Thor Motor Coach Technical Service Bulletin

TSB #	TSB 22-09		
Description/Title:	Rize/Scope A/C install		
Affected Product Line(s):	Certain model year 2022 – 2023 Rize & Scope		
Service Campaign # :	RC000272	Released Date:	
Codes:	Inspect with Repair: TMCTS80249W	Document Date:	7/5/2022
Time Allowed:	Inspect with Repair: 2.0/hrs	Document Revision:	A

Rize/Scope A/C not installed correctly.

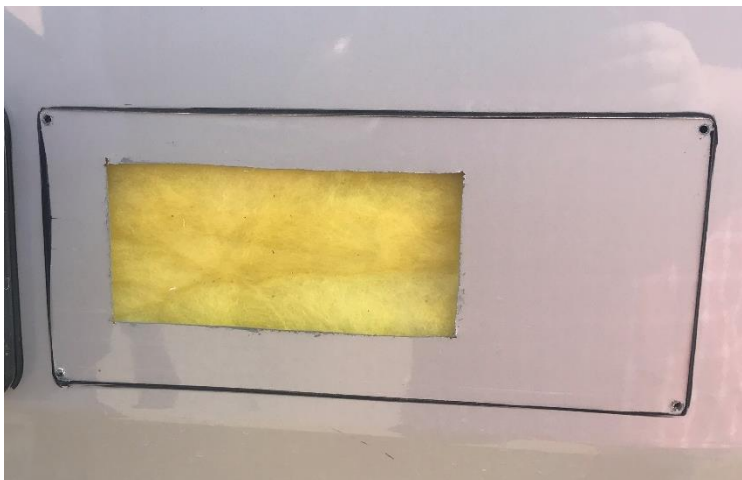
1. The outside intake vent hole may not be cut large enough. Please use attached prints to confirm cutout size and cut larger is needed.

2. Ensure there is no insulation blocking the intake opening.

3. Seal needs to be added around the opening between the intake plenum & van body.

4. Remove two black Southco latches in the front of the cabinet. Loosen and remove the red strap holding the A/C in place and remove A/C to access exhaust.

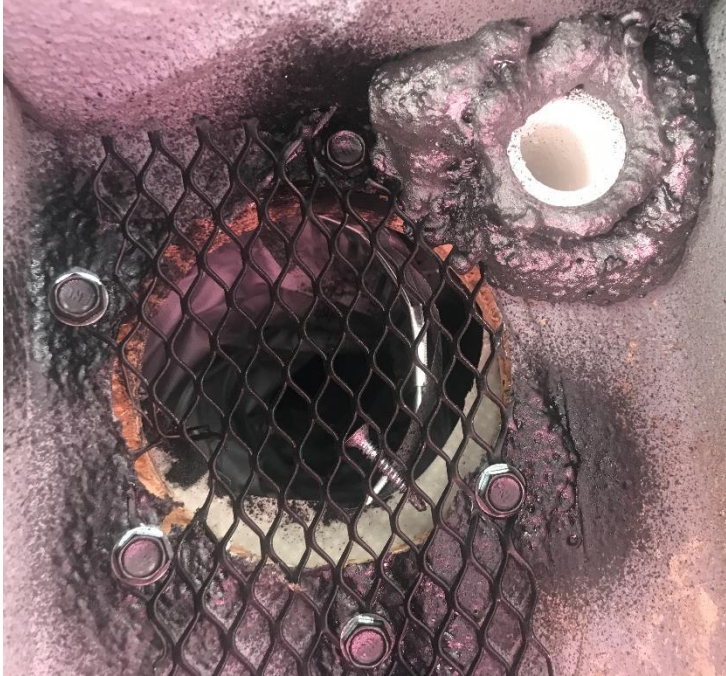
5. A/C exhaust plenum #16 on the TIP0425 print is not lined up with the air exhaust opening. The screws need to be removed and the plenum slid rearward. The strap needs to be moved clear as well.

6. Exhaust flange at the floor is not lined up with the hole in the floor and the floor hole is too small. (hole in floor is 3.5" and should be 4")

7. Mesh cover not installed properly & wrong size, should be a larger piece and needs secured to bottom of frame rail. TFM7703

8. Exhaust hose may be too long and should have the excess cut off to keep the hose from kinking.
